**AMENDMENTS TO THE FIGURES**

Title: "Data Collection System"  
 Inventors: Monroe et al. Application No.: 09/400,624 Docket No.: 42P11599  
 Blakely, Sokoloff, Taylor & Zafman 303-740-1980

FIG. 10

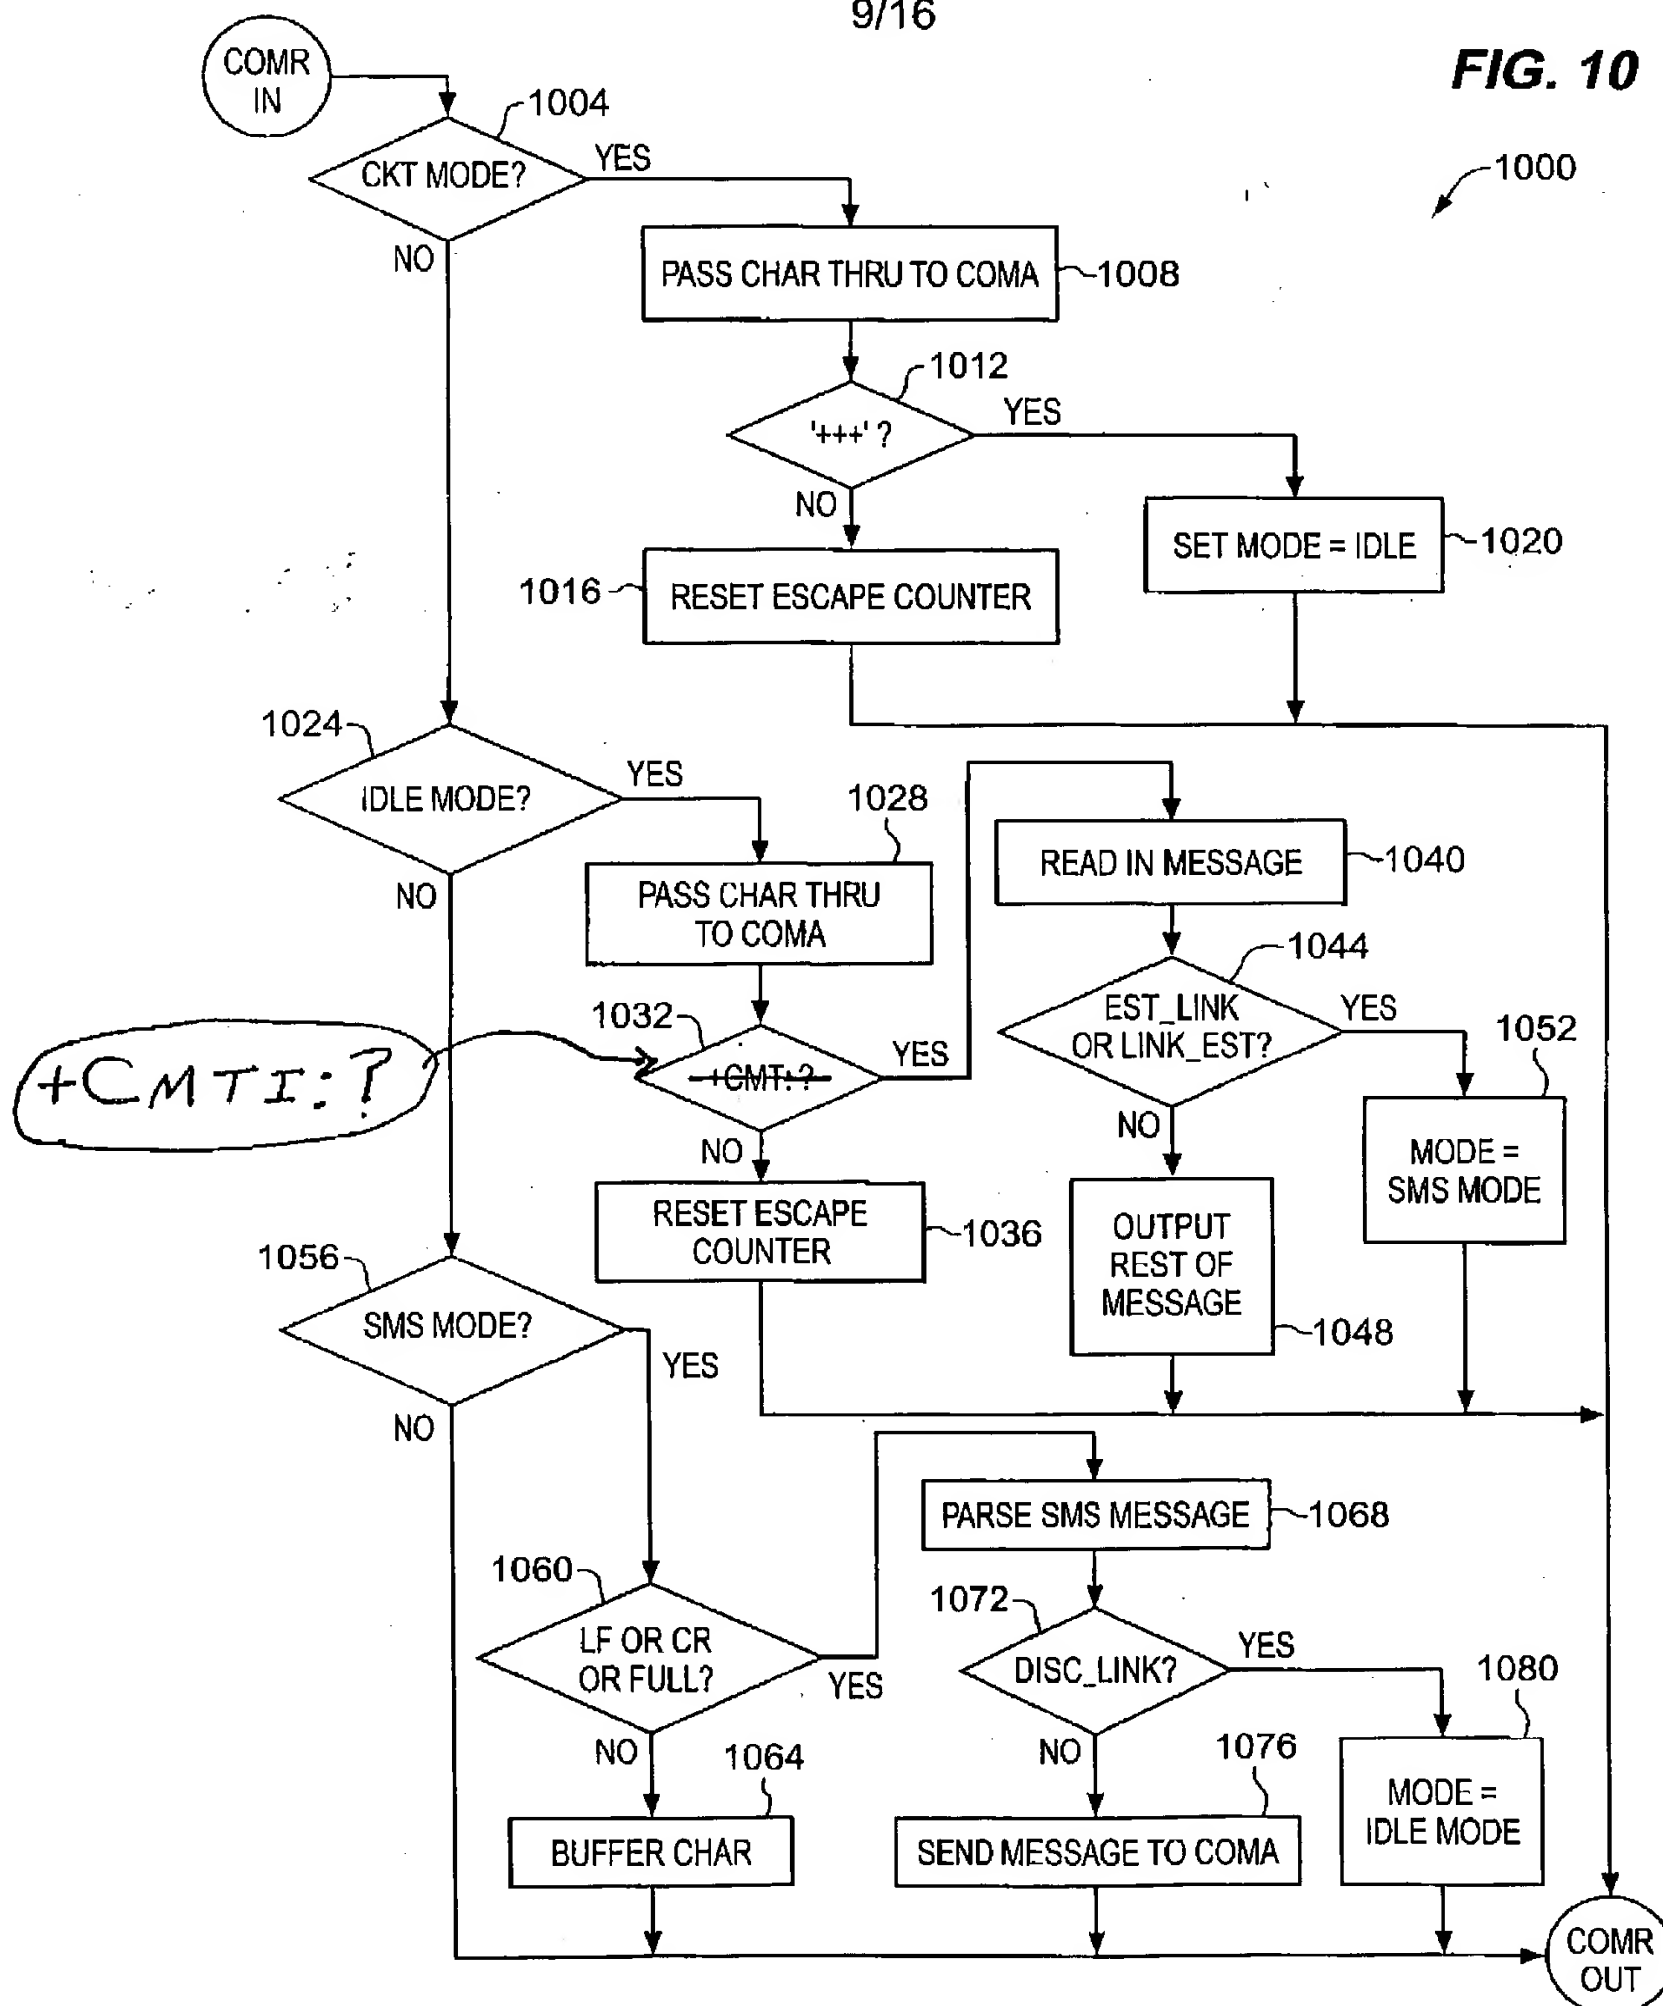
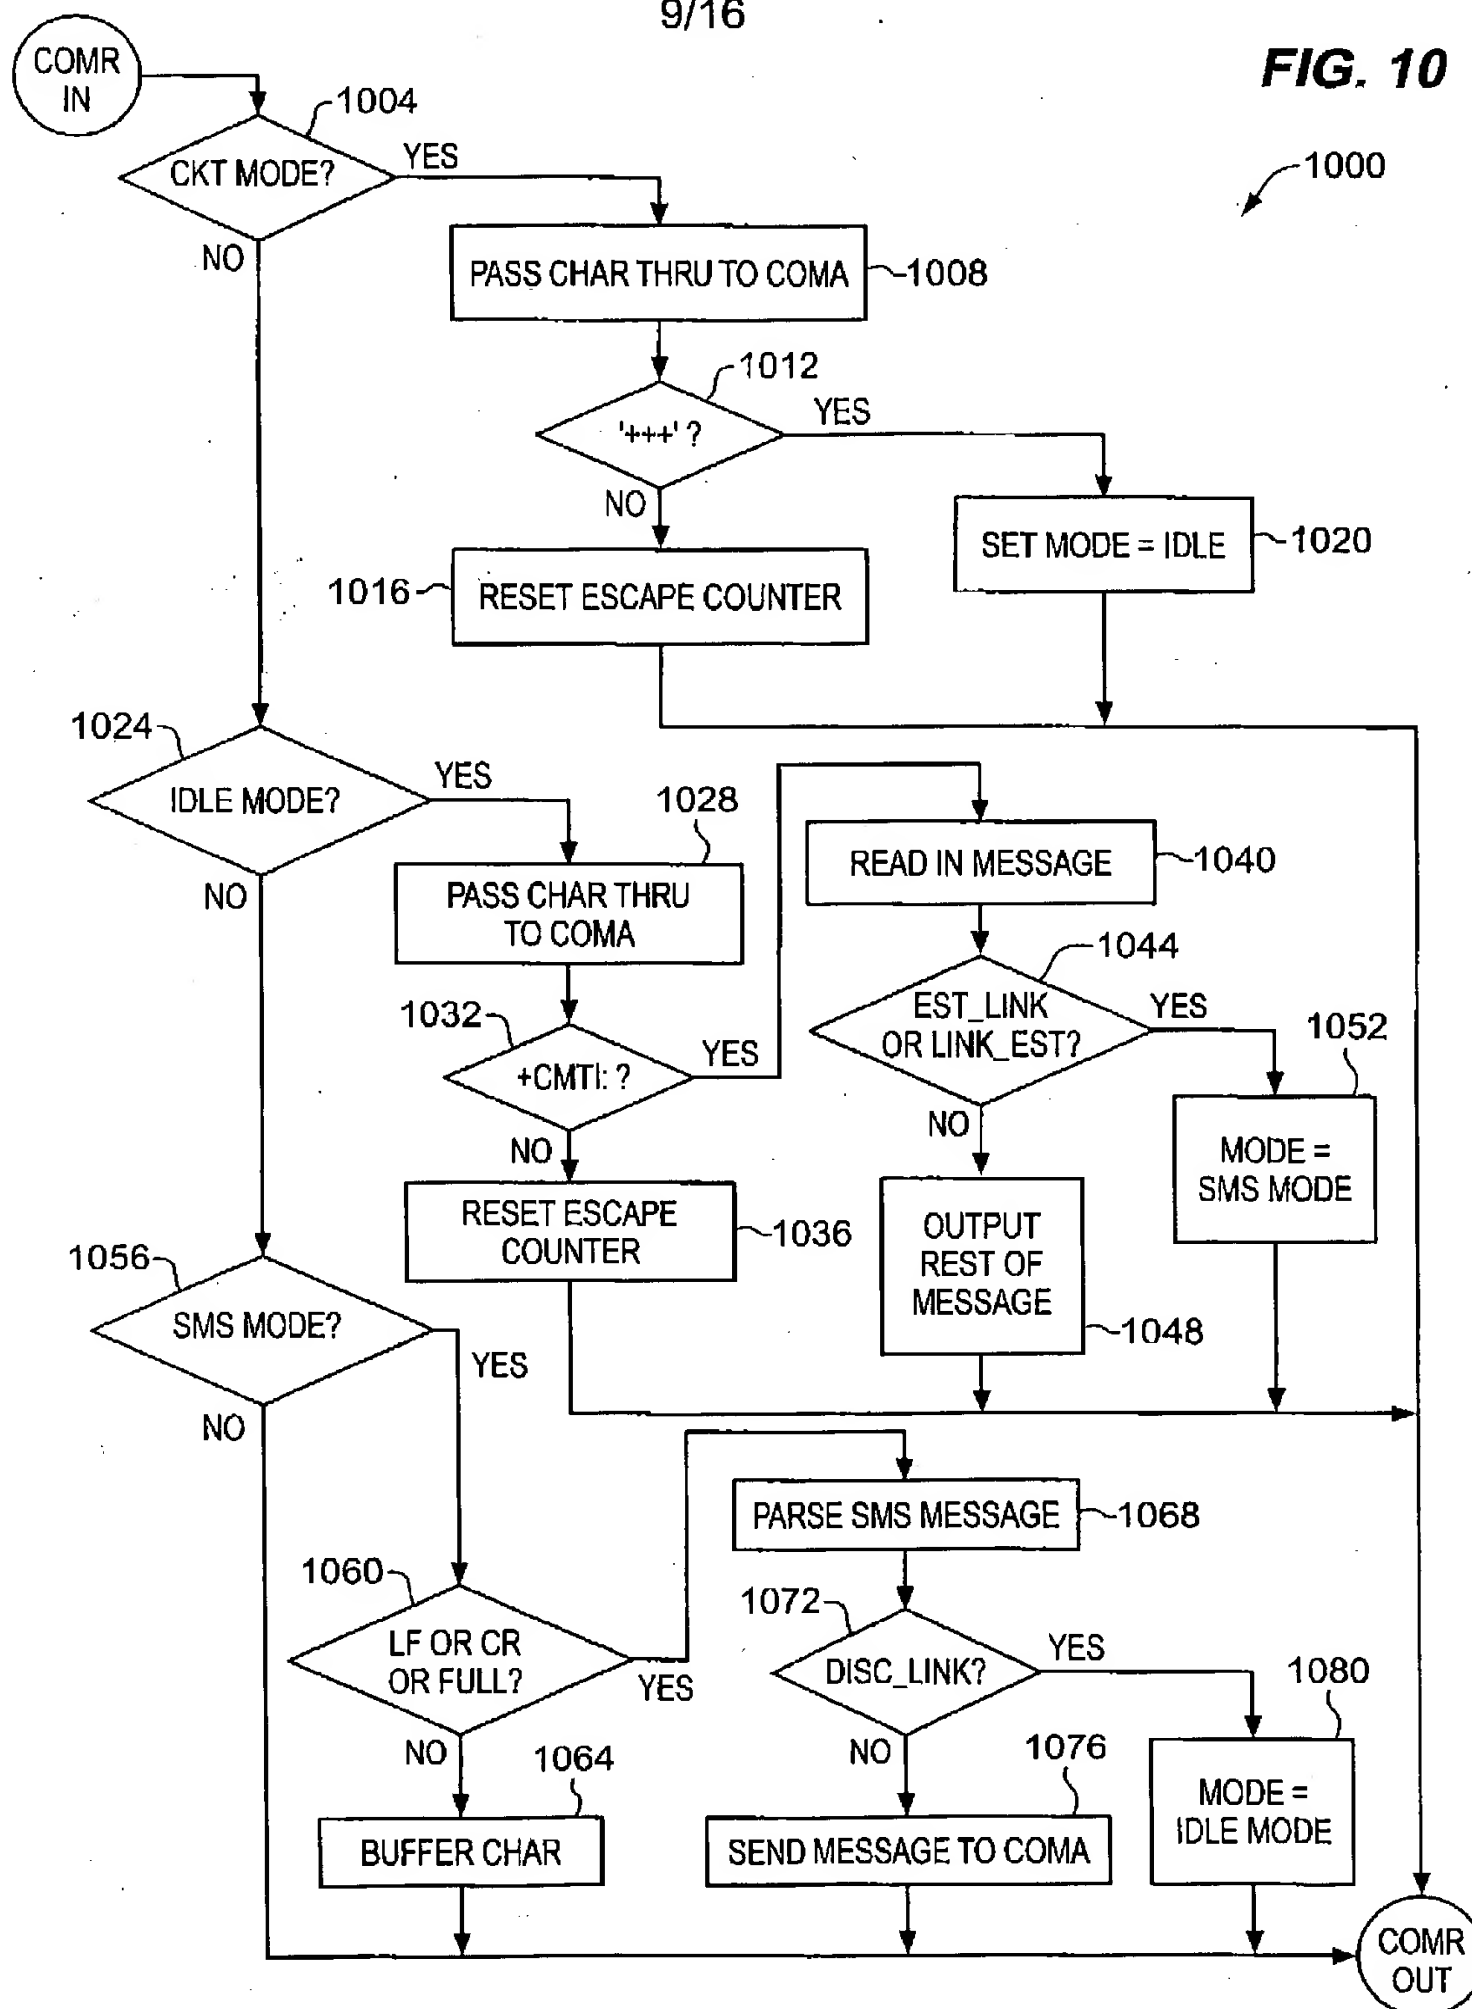
**Figure 10** -- The link sequence "+CMT:" (element 1032) has been corrected to read "+CMTI:".

FIG. 15c

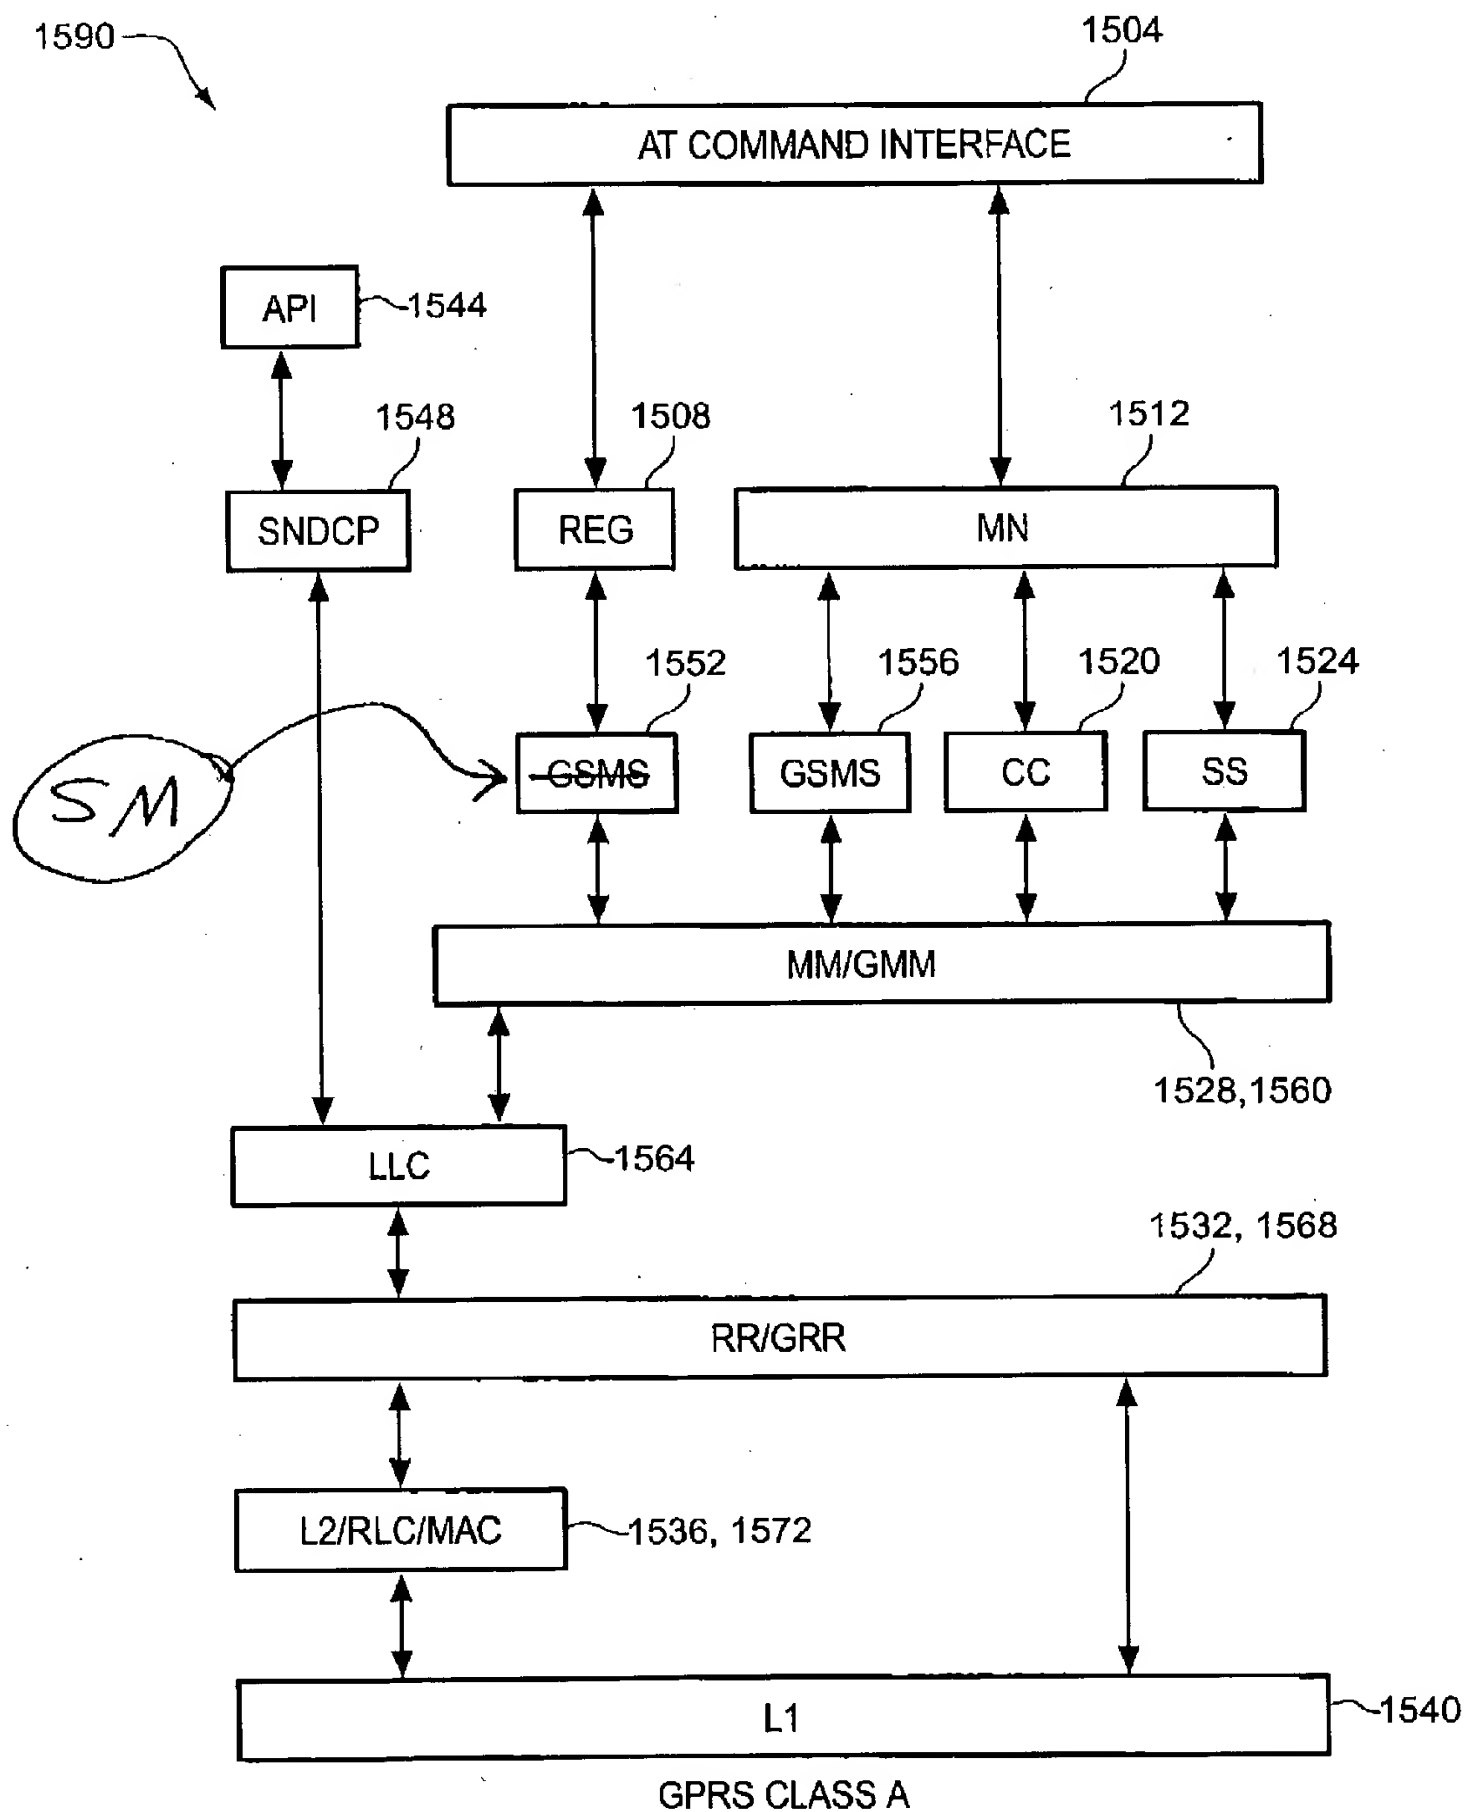
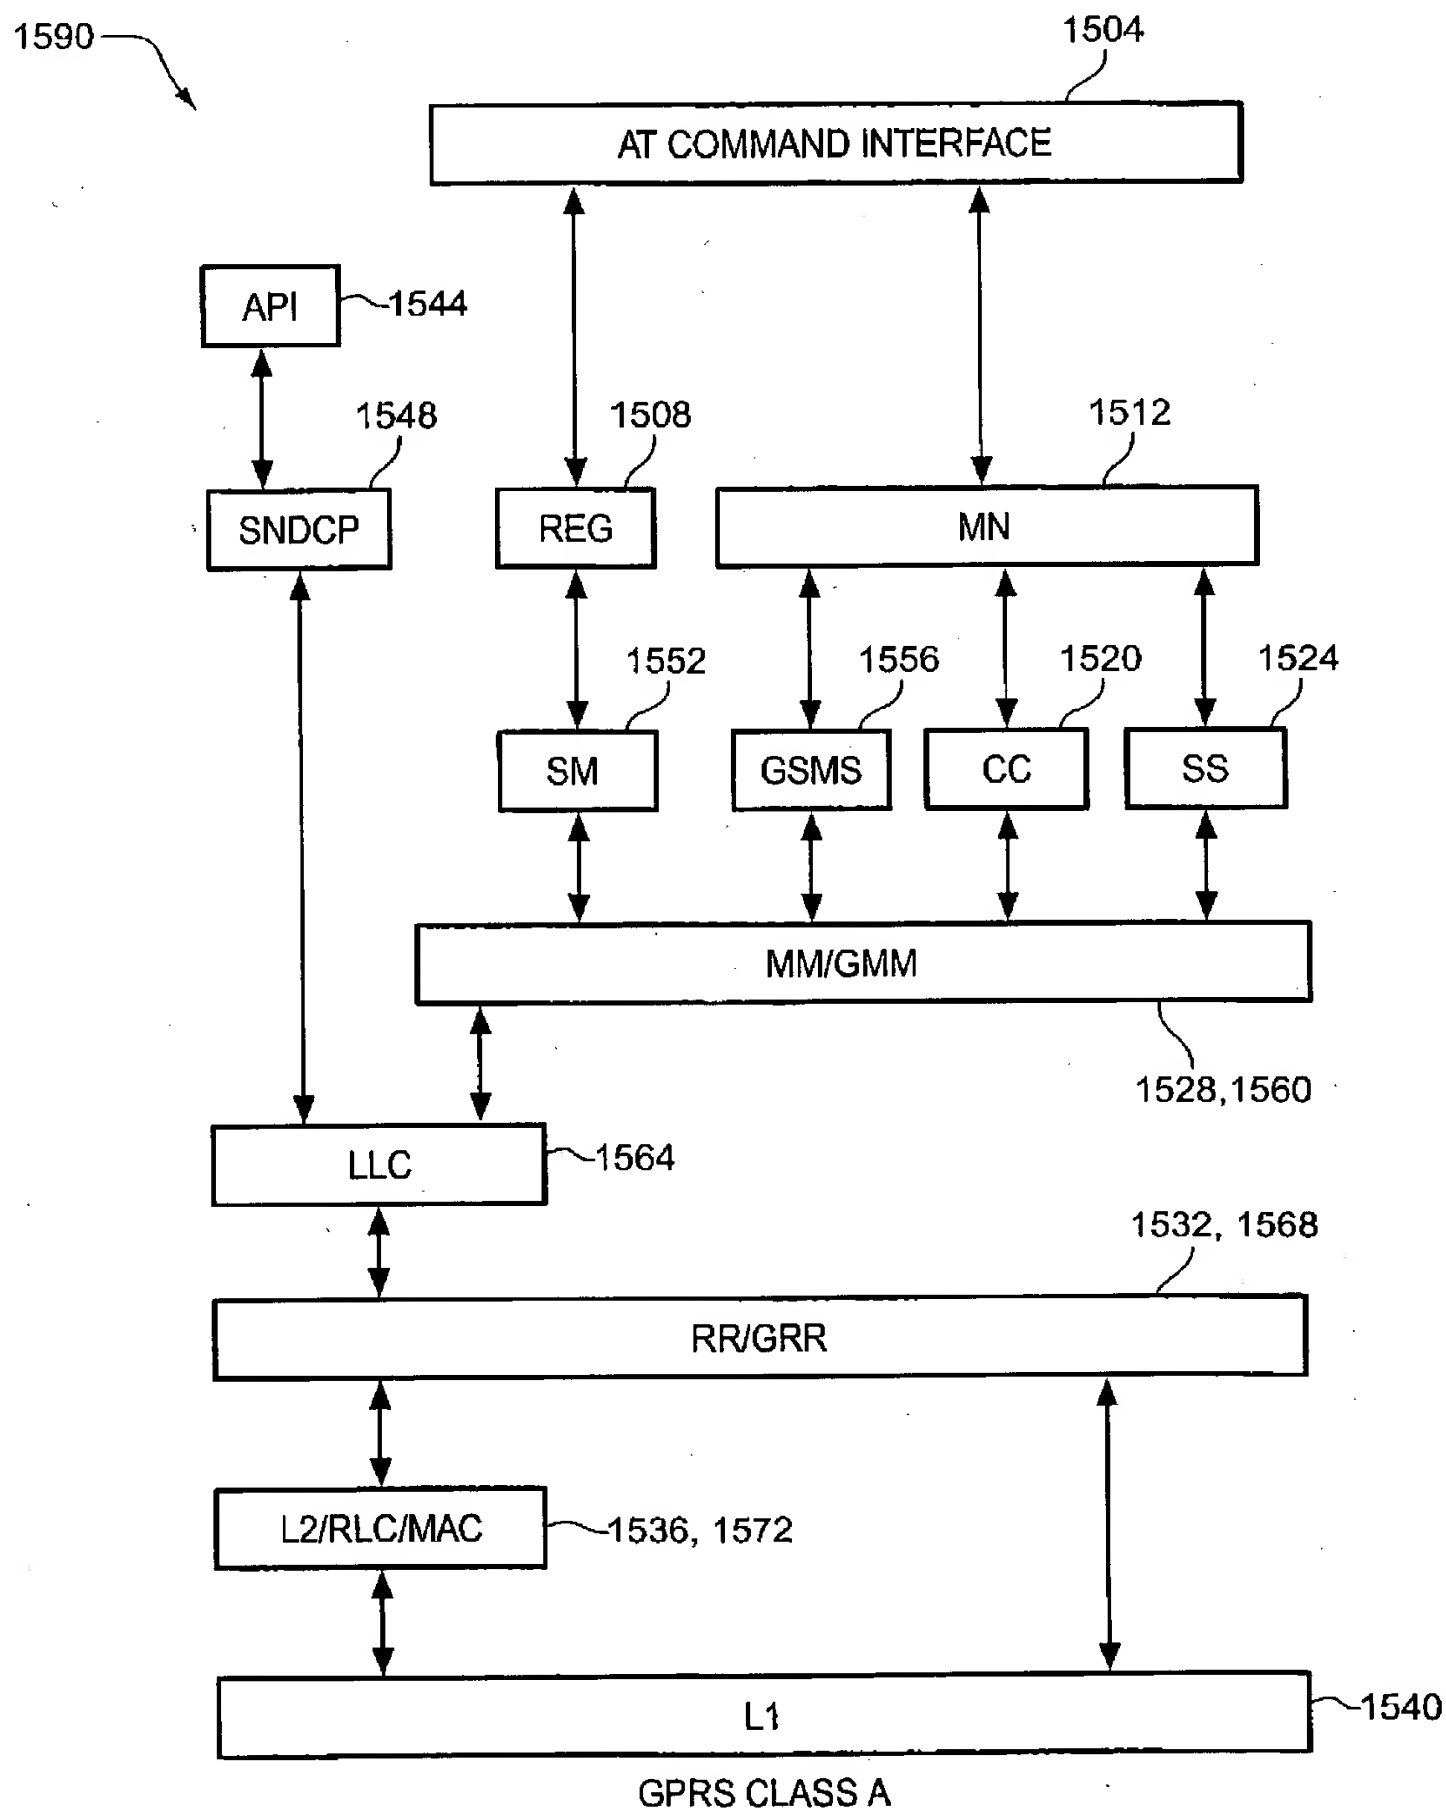
**Figure 15** -- The designation for the SM layer (element 1552) has been corrected to read "SM" instead of "GSMS".
